## **Addendum #1, May 30, 2024**

### **Family Aquatic Center Painting Project**

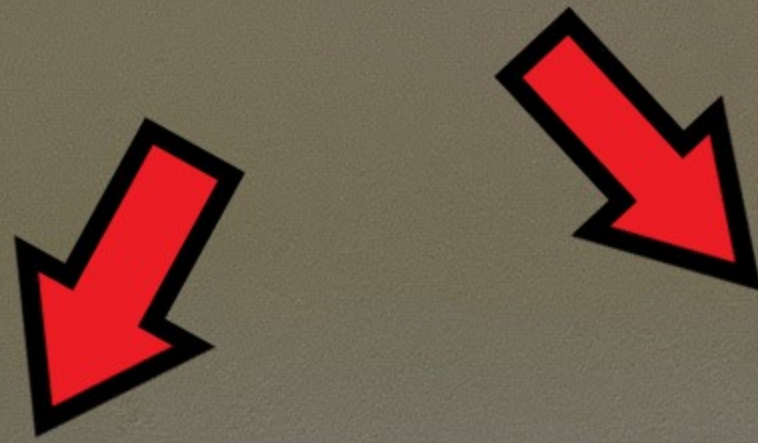
4. Rusting column bases in slide stairwell: Within the stairwell to the slide tower, two steel columns are showing deterioration (rusting) where the column meets the concrete stairs. The Park District is having these areas inspected by a structural engineer who will make a recommendation for repair. Contractor should paint up to these deteriorated areas only. (see photo)

Stop Paint Here

Stop Paint Here
